CARROLL HEALTHCARE - CARROLL HOSPITAL GROUP
INVACARE CONTINUING CARE GROUP

HBSW COMMENTS

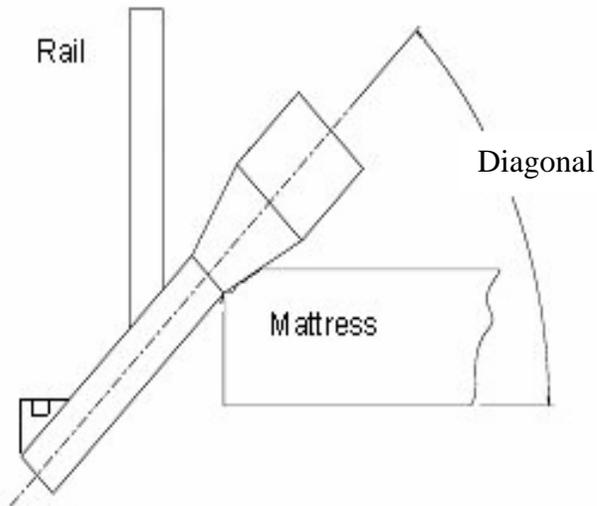
- b. Zone 2 and Zone 4 directs: ...FDA is recommending a diagonal dimensional limit less than 2-1/3" inches in Zone 4 (4-3/4" in Zone 2) ... from the inside bottom edge of the rail... to the top of a compressed mattress... These directions are correct only if the HBSW Assessment Tool is used for the measurement; following the directions as described (without the assessment tool) can actually lead to higher risks of entrapment (see illustration below).

** Case 2 where the Diagonal is less than 2-1/3" has a higher risk of entrapment than Case 1 where the Diagonal = 2-1/3". The desired results would be achieved if the HBSW assessment tool and method were used as illustrated below.*

CHC recommends using the HBSW assessment tool and method for diagonal measurements. CHC also recommends that where the HBSW Assessment Methods are specified that the entire HBSW Assessment Method be defined in the Guidance either directly or by reference.
